Response to Technical Queries on Energy and Sustainability

March 2021

Oriel
Creating the centre for
advancing eye health

Oriel – Response to technical queries on Energy and Sustainability – 17th March 2021

Figure 2 Oriel proposed energy strategy: Energy Hierarchy CO₂ baseline, emissions and savings

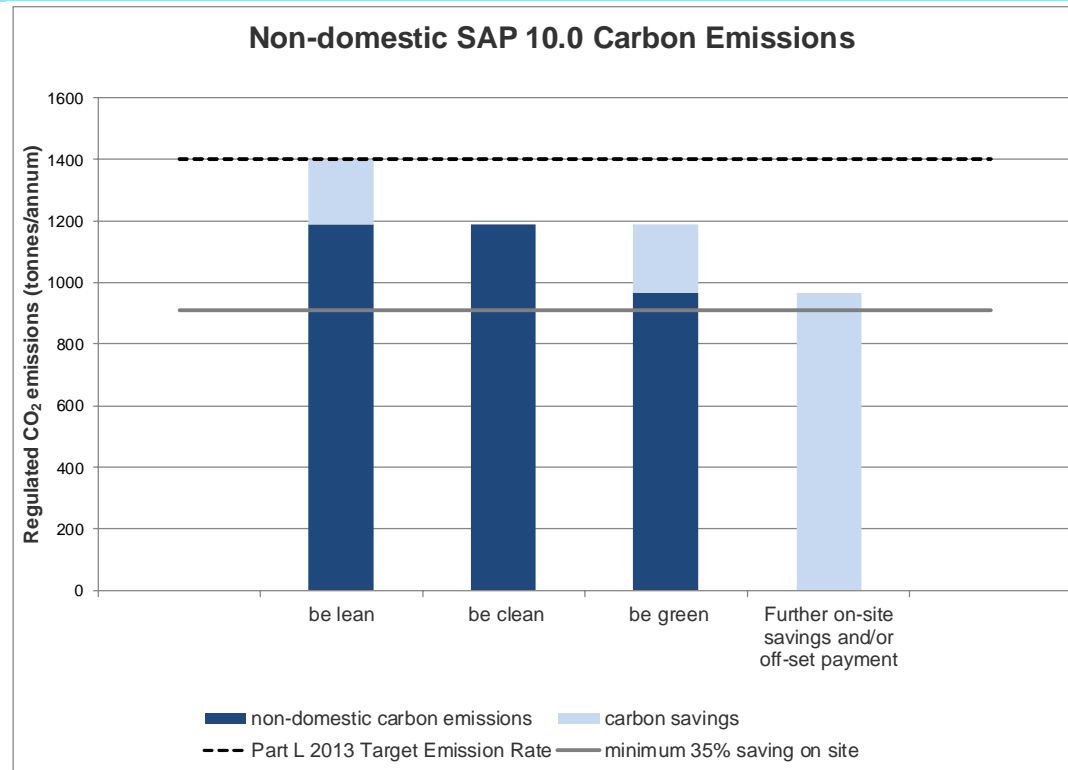
5	<p>The proposed Solar PV arrays are welcomed.</p> <p>Condition recommended.</p>	An appropriately worded planning condition relating to the use of Solar PV arrays within the proposed development is acceptable.
6	<p>Further investigation of the canal for Water Source Heat Pumps is welcomed. A detailed feasibility study should be provided.</p> <p>Condition recommended.</p>	Further information has been received from the Canal and River Trust (CRT) including likely heating/cooling capacity and temperature profiles. Using this information, AECOM has undertaken initial calculations to calculate new average heat pump efficiencies for the proposed building. These have been inputted into the building energy model to produce an updated "be green" stage carbon calculation. These calculations show that there is the potential for the canal to provide an additional 53.4 tCO ₂ /year of carbon savings to the proposed building.

Query No.	LBC Query	Applicant's Response																		
		<p>Therefore, an appropriately worded planning condition to undertake a study to review the financial, legal and technical feasibility of the use of the canal as a heat source for the proposed building is acceptable.</p> <p>Tables 2 and 3 below provide an indicative estimate of carbon savings at each stage in the energy hierarchy if the canal were to be included as a heat source. Note that the figures in the table are subject to detailed technical feasibility and design.</p>

<p>Table 3 Regulated carbon dioxide savings from each stage of the energy hierarchy, including canal source heat pumps</p> <p>As shown in Tables 2 and 3 above, incorporation of the canal water source heat pump has increased the savings from the “be green” stage of the energy hierarchy from 12% to 16%, and overall savings from 27% to 31%.</p>		(Tonnes CO ₂ per annum)	(%)	Savings from energy demand reduction	210.7	15%	Savings from heat network/CHP	0.0	0%	Savings from renewable energy	226.5	16%	Total cumulative savings	437.1	31%
	(Tonnes CO ₂ per annum)	(%)															
Savings from energy demand reduction	210.7	15%															
Savings from heat network/CHP	0.0	0%															
Savings from renewable energy	226.5	16%															
Total cumulative savings	437.1	31%

Further discussions are proposed to take place post-planning with the Canal and River Trust to continue exploration of this option as part of a feasibility study. Issues surrounding suitable access points, land ownership and Environment Agency licencing remain to be reconciled to allow the building to take advantage of these carbon savings.
